North Hertfordshire District Council

Building Conservation comments

File Ref: 24/02606/FP

Subject: Erection of three detached dwellings (1 x 3-bed, 1 x 4-bed and 1 x 5-bed) and with associated infrastructure and landscaping.

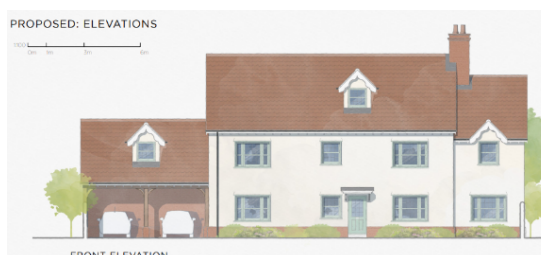
3.7 Senior Conservation Officer: Conservation surgery discussion and considers that overall harm to designated heritage assets is within the lower end of the less than substantial harm test set out in paragraph 202 of the NPPF. Considers that

some harm would be caused by the larger dwelling proposed on plot 3 to be of a scale that would be dominant within the courtyard setting when compared with the smaller barn style dwellings on plots 1 and 2.
